Upper Trishuli-1 HEP (216MW)

DOOSAN NEPAL BRANCH OFFICE	Address & Contact No. : Four Square Building, Naxal, Kathmandu, Nepal (P.O Box : 1387) + 977 1 692 3014	Project No. H20002	DOCUMENT DISPATCHED BY Courier Service ☐ Messenger ☐ Post-Air Freight ☐ Document System or E-mail ■ By hand ■
DOCUMENT DISTRIBUTION	■ POWER CHINA (Subcontractor) ☐ Doosan's Site Office		
SUBJECT	Review Note RN-0108_Outline Drawing of Diversion Tunnel Lining

REVIEW NOTE

Contractor	**Doosan Heavy Industries & Construction Co., Ltd.**		
Title of the Document	Diversion Tunnel, outline drawing		
Document No.	UT1-C-010-CVL-DG-42005	Revision	0A
Date of Documents	15.03.2022	Received Date	16.03.2022
Transmittal Form No.	UT1-HEP-DHI-D-0184		
Previous Review Date/Status	N/A	Prev. Review Note No.	N/A
Review Note No.	**RN-0108**	**Present Review Date**	**30.03.2022**
		Present Review Status	**RR**

LONGITUDINAL PROFILE OF DIVERSION TUNNEL

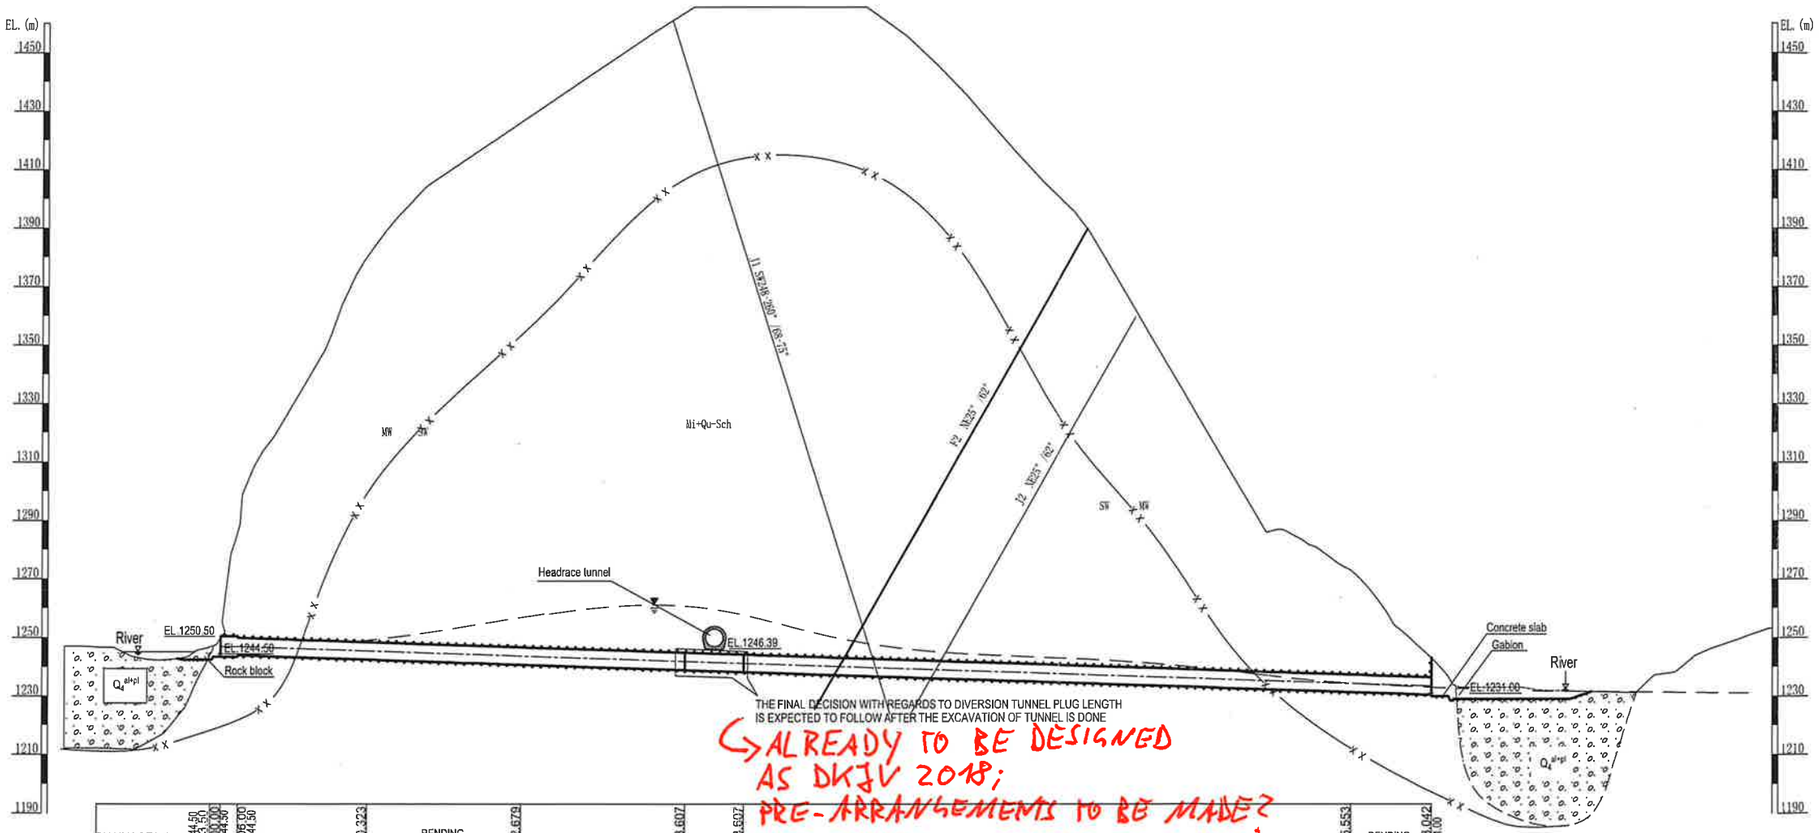
ALREADY TO BE DESIGNED AS DKJV 2018; PRE-ARRANGEMENTS TO BE MADE?

RECEPTION DATE
↓
COMMENCEMENT OF WORKS

COMMENTS TO SHEET 2 OF THIS DOCUMENT ARE VALID AS WELL.

TYPICAL CROSS SECTION D1
(for rock class II)

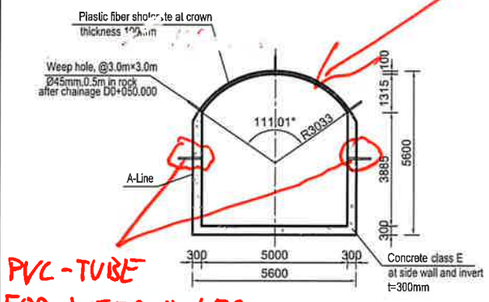
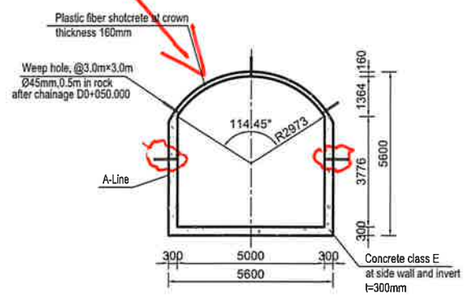
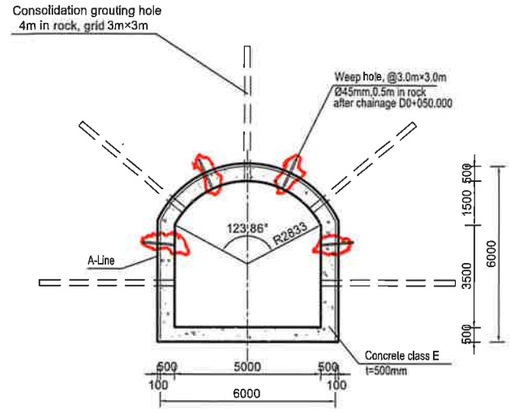
HIGH FLOW VELOCITIES WITH ABRASIVE MATERIAL SHALL BE CONSIDERED ⇒ FULL REINFORCED CONCRETE LINING SHALL BE CONSIDERED

PVC-TUBE FOR WEEP HOLES IN REINFORCED CONCRETE LINING
↳ EPC CONTRACT ANNEX 13, PART C, 1. CONSTR. SPEC., 18.3.24.

TYPICAL CROSS SECTION D4
(for intersection of headrace and diversion tunnel)

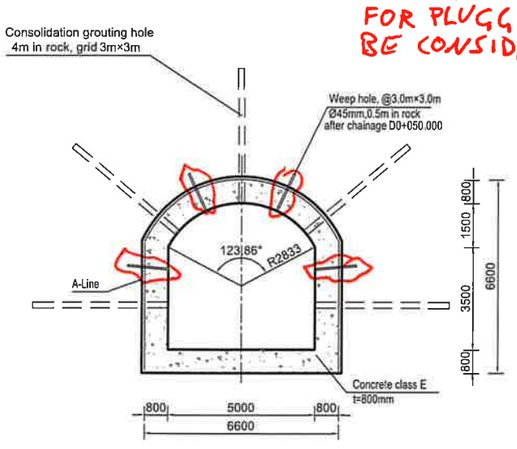
PRE-MEASURES FOR PLUGGING TO BE CONSIDERED?

TYPICAL CROSS SECTION D5
(for inlet section) / OUTLET SECTION?

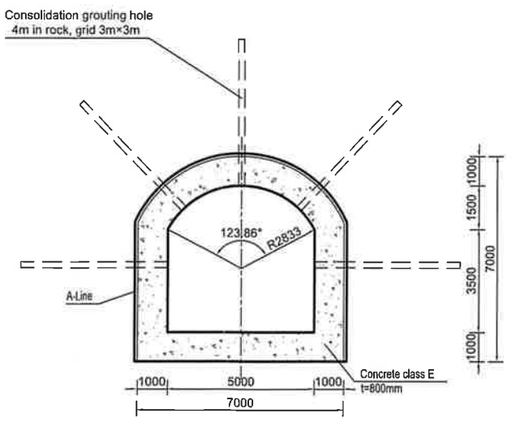
HORIZONTAL WATERSTOPS ACCORDING TO UT1-C-010-CVL-MS-80013, SUBCHAPTER 9.3.2(2) HAVE TO BE INDICATED WHERE APPLICABLE

- LEAN CONCRETE?
- WEEP HOLES IN TUNNEL BOTTOM SLAB?
- BLOCK JOINTS / DETAILS?
- TRANSITION CONCRETE LINING ↔ SHOTCRETE LINING TUNNEL ROOF? → HIGH FLOW VELOCITIES → CAVITATION

CLASS OF FINISH TO BE INDICATED ACCORDING TO CONTRACT ANNEX 13, C, 1, 15.1.9(2)
